**RE: Lake Okeechobee Protection Plan 2011 Update Recommendations**

This letter constitutes Audubon's comments on the Lake Okeechobee Protection Plan draft update (draft LOPP), released November 9<sup>th</sup>, 2010.<sup>1</sup> While the draft LOPP reflects an impressive amount of agency effort and knowledge, it does not describe a blueprint for the recovery of Lake Okeechobee, its watershed, and the Northern Everglades. The draft LOPP neither articulates the necessary directives, nor supplements such directives with explicit budget proposals and timelines to meet the legislatively mandated phosphorus total maximum daily load (TMDL) by 2015. Therefore, Audubon of Florida offers suggestions regarding source control, water quality treatment, and dispersed water management (DWM) for the draft LOPP update for your consideration.

Figure 1. Legacy loads are increasing rapidly. [The draft LOPP should include a graph like this backdating SWET's 190,000 mt in 2007 using SWET, Mock Roos, and Hiscock estimates of previous annual imports]

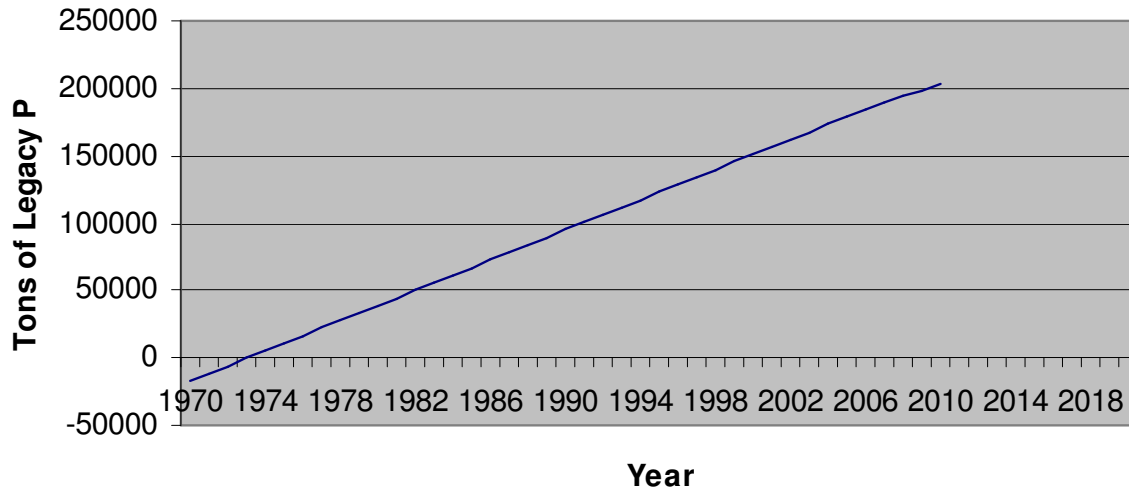
- *The continued accumulation of legacy phosphorus may be one of the most important indicators of the health of the Okeechobee watershed. The release of these legacy phosphorus deposits will eventually surpass annual reductions of phosphorus imports unless more decisive action is taken, beginning with more aggressive source controls. The graph below<sup>5</sup>, prepared by Dr. Paul Gray, Science Coordinator of Audubon of Florida’s Lake Okeechobee Watershed Program, shows the history and continued accumulation of legacy phosphorus. This is happening regardless of the efforts that the SFWMD and other agencies have undertaken.*

**Insert at Line 3807:** “At this rate, the legacy loads have roughly doubled since initiation of the Surface Water Improvement and Management Act (SWIM) in 1989, and risen from about 150,000 mt tons when the LOPA passed in 2000, to about 200,000 mt in 2010, a 33% increase (Fig.1).”
